Agenda Item Number 31  
Meeting Date: 09/20/01

**SUBJECT:** FASCINATIONS #DRB01151

**BRIEF:** Request by City Council to appeal the Design Review Board decision on Fascinations for building elevations, site plan and landscape plan at 838 West Elliot Road.

**COMMENTS:** **DESIGN REVIEW APPEALS (0102-05-03)** Request by City Council to appeal the Design Review Board approval of **FASCINATIONS #DRB01151** for building elevations, site plan and landscape plan located at 838 West Elliot Road.

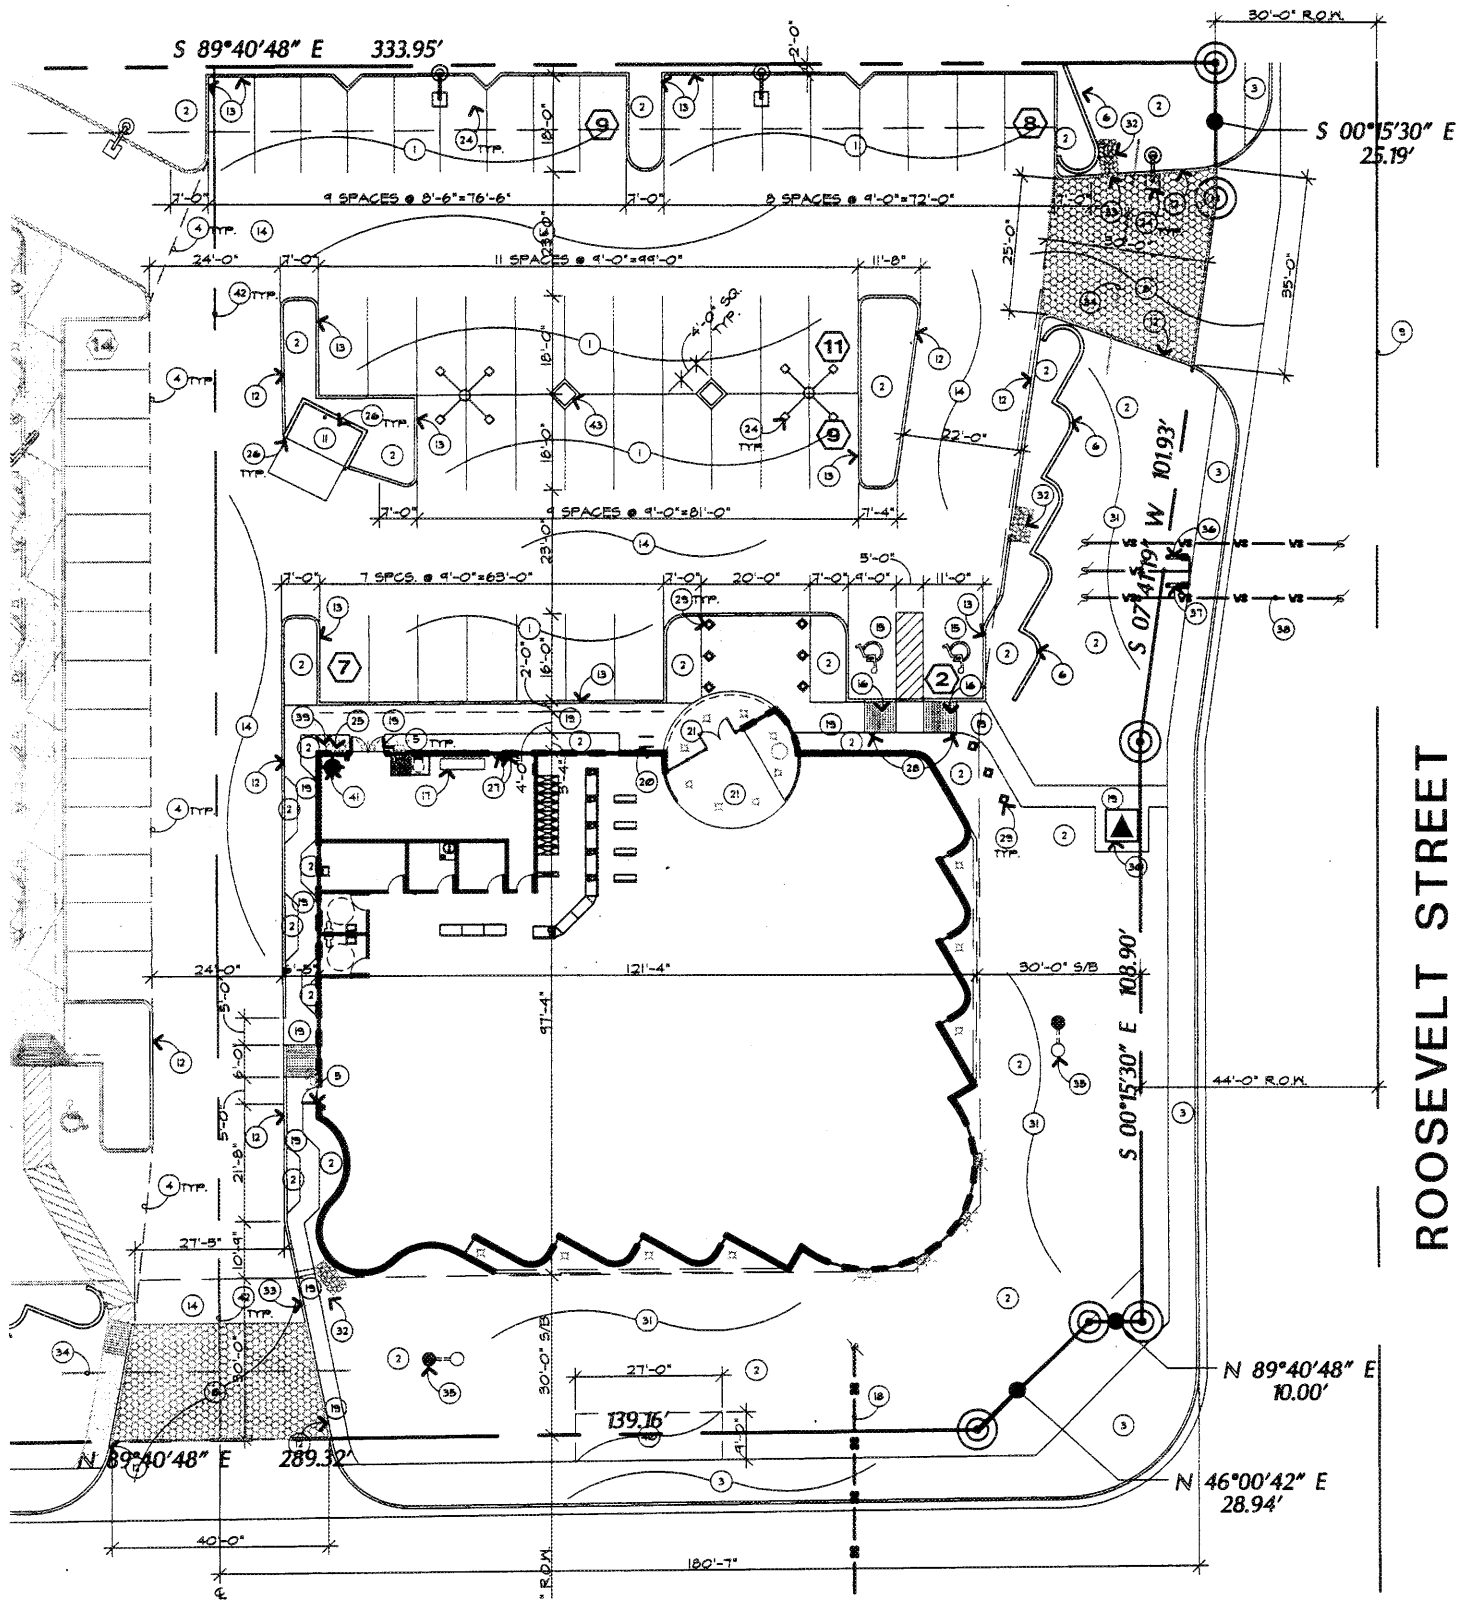
But anyway, that's not the point of my comments. The point of my comments really are going to focus more on the site plan and a little bit on the building. But, several months ago, when we had our first hearing, I stood up here and criticized the site plan because I thought it neglected to take into consideration safety factors that might be involved in this project. I did not, and do not, think that what we're calling here as phase two has been at all integrated into this project. The last time I checked that site was for sale and it's my understanding, I know they've tried to sell it to other people, but I fear that what we have here is an afterthought and I think the applicant is very interested in getting their first building approved and after that is interested in selling the rest of this site to whoever would buy it and leaving the problem up to them, and unfortunately, to me because I plan to be there for awhile. So, I continue to think that the phase two here is an afterthought and not at all integrated.

The landscaping I don't have any comments on, I don't think that's an issue at this point. But just in looking, can we turn the overhead on here, at the existing site plan, what we're calling here is phase two. I assume that's some form of retail use and none of those small retail components, nearly six of them, have any frontage at all and I think earlier we were talking about disinvestment. To me, this is a perfect example of disinvestment waiting to happen. But again, I really don't believe that anybody really thinks that's going to get built, and I think it's just being thrown up there with some elevations to get what they really want to get done, is the big building on the corner and let somebody else worry about this site. And I think you all are here to be concerned with this and I certainly am.

Mr. Nicpon: Well, let me just comment on my thoughts. As far as site plan is concerned, and I'm going to offer some suggestions why I think the site plan is wrong. First of all, it hasn't changed from the proposals or the presentations that I've seen to date. It's still essentially the building that's forward. I have heard from many people, as well as a lot of documentation that were sent to me via staff and to my house from Fascinations, that essentially the business is destination in its orientation. And as such, as a destination, it is not necessary from that standpoint to be on the corner when in fact it is destination in nature. Secondly, the building is on the going-to-work side which portends that a destination business, a destination retail establishment, can be placed anywhere. So if it can be placed anywhere relative to the site it's probably best from a retail standpoint being destination to be placed in back. So, that's another consideration.

Mr. Jagos: I'm sorry, my name is Patrick Jagos, I'm at 1219 West Geneva, Tempe. The reason that the building is on the corner like that is to make the most efficient use of the land. We were told to have the parking in the rear by Planning, so that is basically why it's on the corner. The reason we don't shuffle it over into the other parcel or the future phase is, if somebody chooses to buy that we want to give them as much flexibility with that parcel, and if we start intruding into that, it's really not going to be a feasible site for anybody to use.

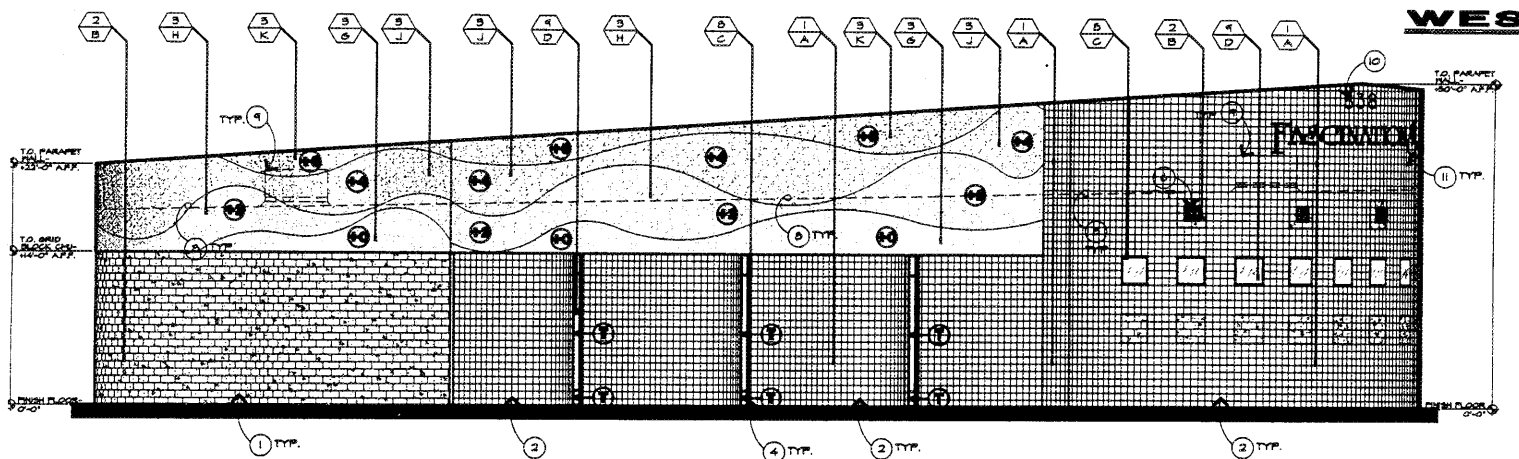
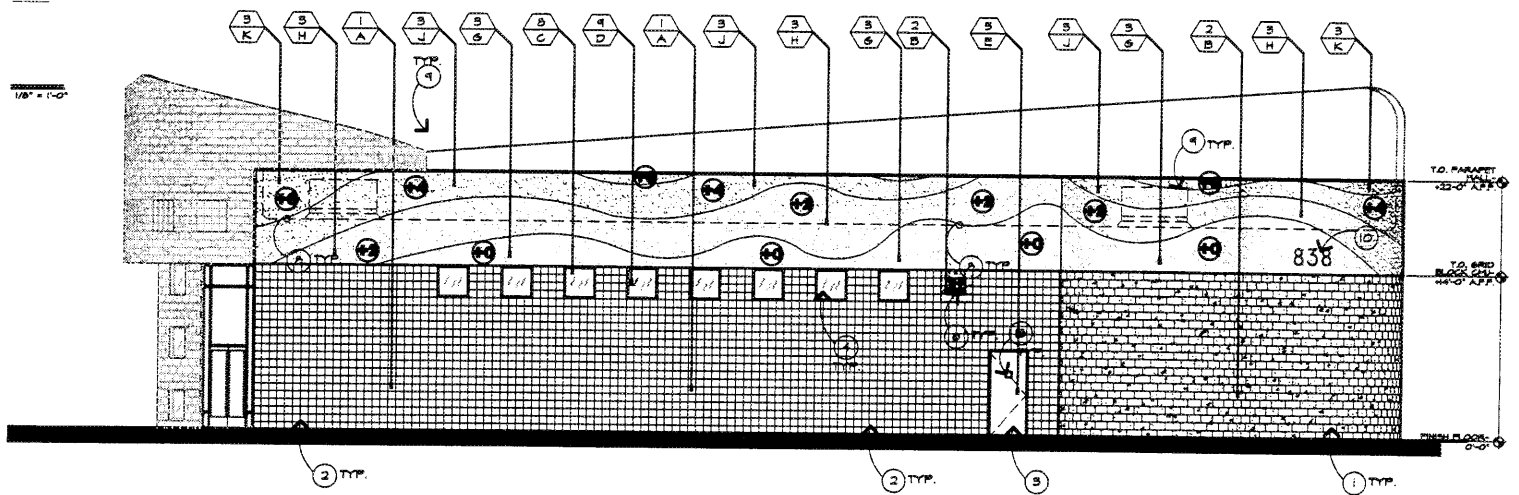
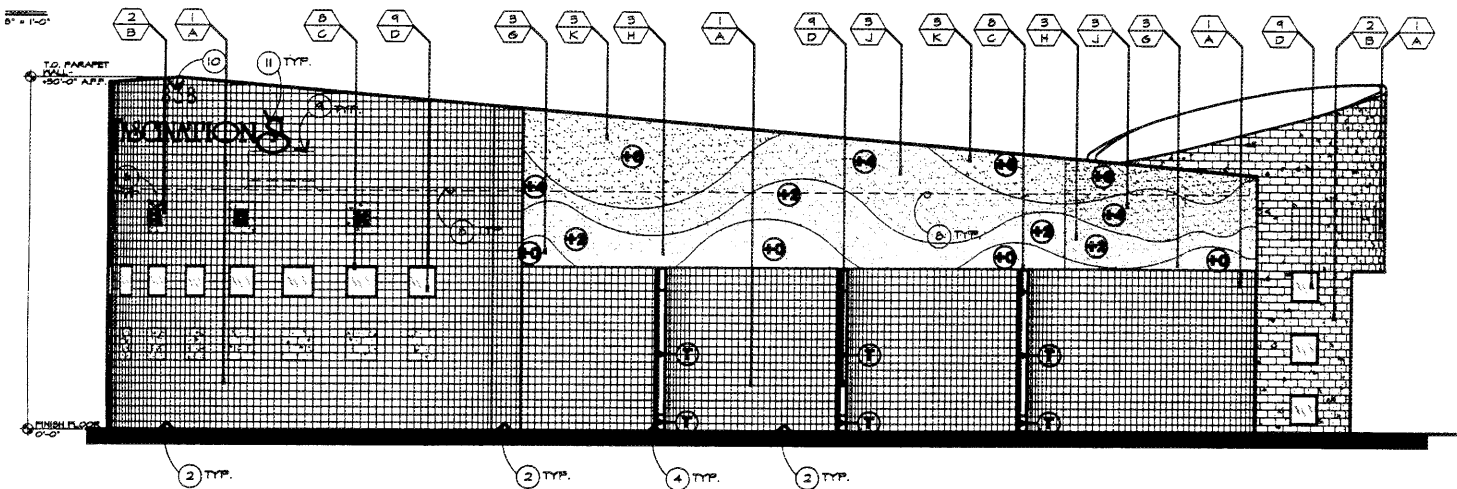
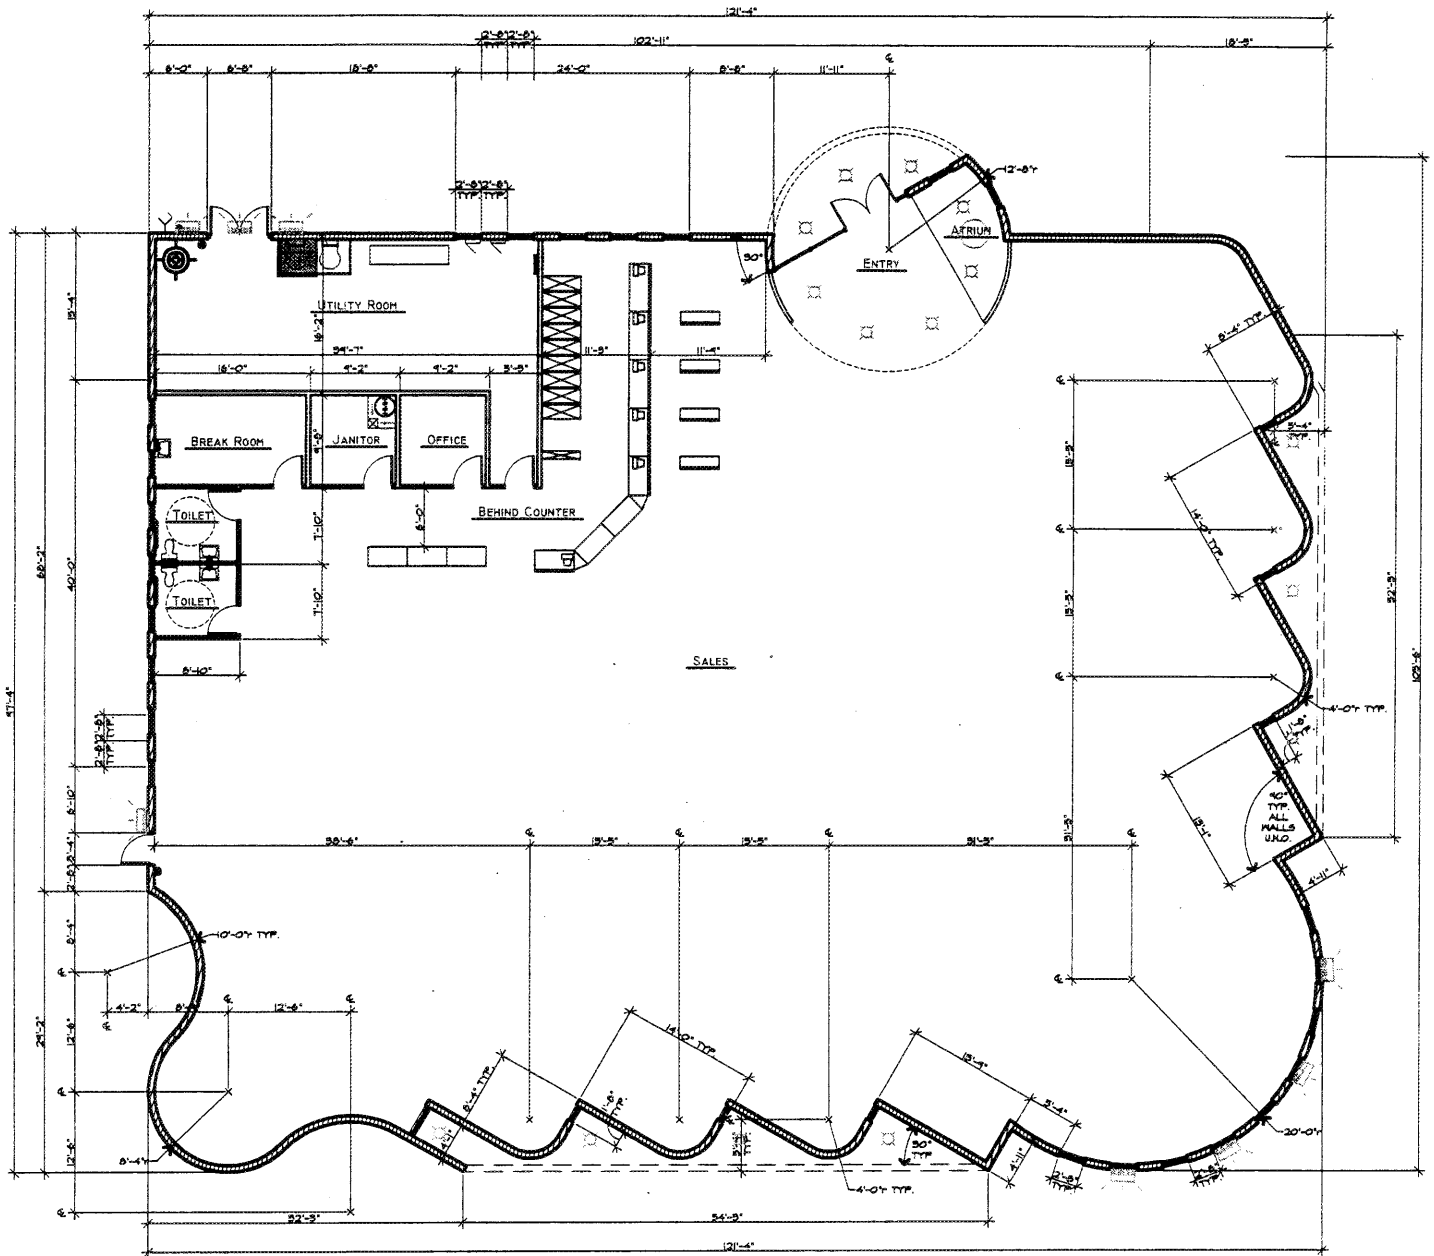
15. Provide additional details of the two (2) inch thick layers of the parapet wall so that construction of the substrate will allow/support the six (6) inch thick projection at the upper portion of the parapet.
16. Incorporate scuppers and downspouts into building elevations so that they do not detract from the building architecture.
17. Locate roof access ladder inside the building.

Mr. Voss: Question for staff. I am not understanding stipulation #15 with regards to the thickness of the parapet wall. I couldn't find a definition of what that thickness is in the submittal, maybe they missed it. Then I got more confused when I read the stipulation.

Mr. Voss: I think particularly in this design where you have a parapet wall that's climbing away from you, and from a distance you might see that raised parapet top edge, normally you wouldn't see that on a building, and I guess that's where my concern is. The landscape plan has a mixture of elm trees and desert trees. Is there a particular reason why that was done?

Mr. Kersbergen: The stipulation is asking that, when we see building details for the construction of this, that that would be explained sufficient that we can understand it. What the intention of this condition was is that that 2 in. pop out dimension that's described doesn't get turned into something different at a later point for some other reason. If there's another constructability issue that says its easier to do that at one inch, we don't want to see that change happen.

Mr. Hunse: The higher bands in the parapet, as it goes up, they project up 2 inches, 2 inches, 2 inches, so that, and what they're asking for is a construction detail at the appropriate time that supports that design. We haven't done it yet. We've talked to two or three contractors about it and we don't feel that it is a particularly difficult thing to accomplish.
